SUBJECT: COMANCHE PEAK NUCLEAR POWER PLANT, UNITS 3 AND 4
DOCKET NUMBERS 52-034 AND 52-035
RESPONSE TO REQUEST FOR ADDITIONAL INFORMATION NO. 4619 AND 4638

Response to Request for Additional Information No. 4619 (CP RAI #165)

RAI NO.: 4619 (CP RAI #165)

SRP SECTION: 19 - Probabilistic Risk Assessment and Severe Accident Evaluation

Figure 18.--All-season PMP (in.) for 6 hr 10 mi² (26 km²).

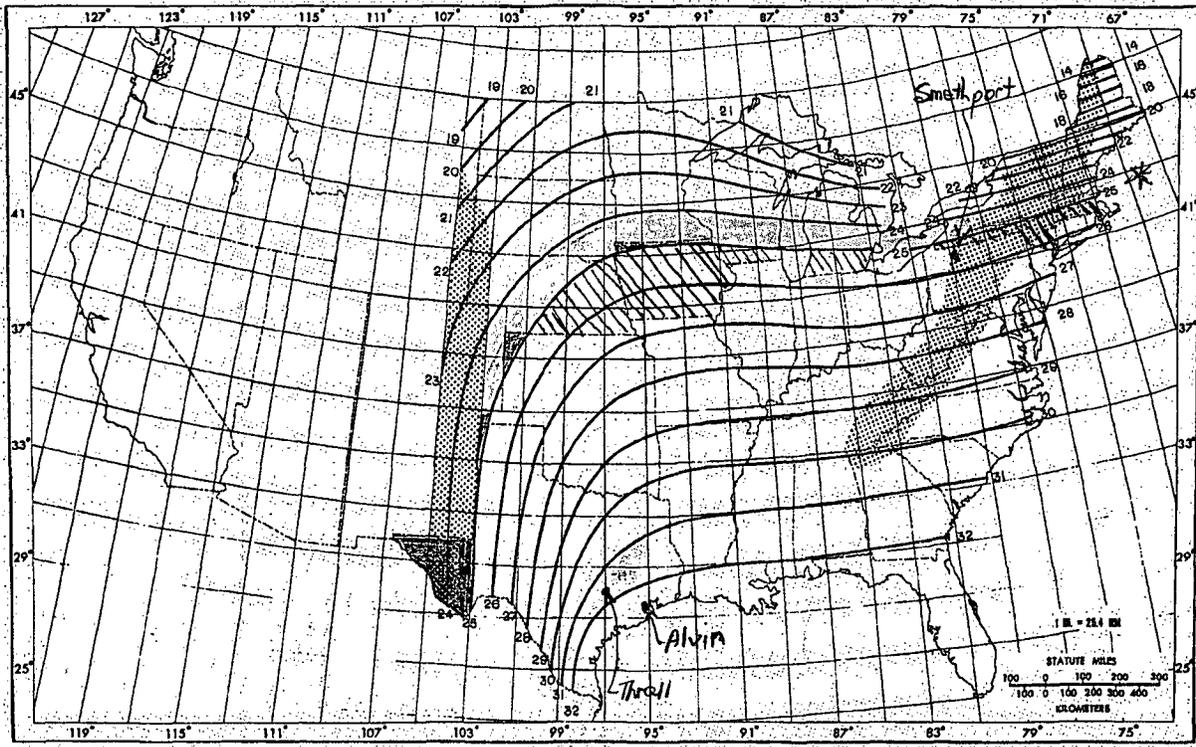
- (b) Please clarify the description of probable maximum flood (PMF) in Table 19.1-205 of Revision 1 of the CPNPP Units 3 and 4 COL FSAR. It is stated that the PMF and maximum coincident wind wave activity results in a flood elevation of 809.28 ft msl and the top elevation of the retaining wall is 805 ft msl. What is the location of the flood elevation of 809.28 ft msl and that of the retaining wall? Qualitative or quantitative arguments are needed, in conjunction with the evaluation of plant design bases, to show that the probable maximum flood is indeed an insignificant contributor to the total CDF from all initiating events.

The three locations for the rainfall events considered in the estimation of PMF frequency (Smethport, PA, Thrall, TX and Alvin, TX) are superimposed on Figure 18 from Reference 4 (below). This figure includes isopleths for various PMPs. The isopleth for 25-inch rainfall passes near Smethport and includes both Thrall and Alvin. The area enclosed by this 25-inch contour is the area of the U.S. that could experience extreme rainfall events equal to or greater than the three events identified above.

Figure 18 shows that there are many states that are completely included in the PMP area. Note that there are two bands of shading from the original map, a north-south band on the west of the PMP region, and a southwest-northeast band along the Appalachian Mountains that indicate areas not included in the PMP calculations. Portions of states that are not totally enclosed in the PMP area are indicated with dark shading. The cross-hatched areas are part of the PMP area but are not included in the calculation of total PMP area to compensate for the two areas (shaded and dark shaded) discussed above. It can be seen that the shaded and

Therefore, the frequency of a PMP of 25 inches over 10 square miles is estimated to be 1.4×10^{-7} per year. This is a conservative estimate of the frequency of the PMP that results in a PMF for CNNPP Units 3 and 4 because additional periods of significant rainfall must also occur in close temporal proximity to the 25-inch 6-hour rainfall event. Given the calculated PMF is not projected to reach the safety-related elevation of the plant and the estimated PMP and PMF frequency of 1.4×10^{-7} /year, the frequency of a flooding event that would reach the safety-related elevation of the plant is projected to be well below 10^{-7} per year.
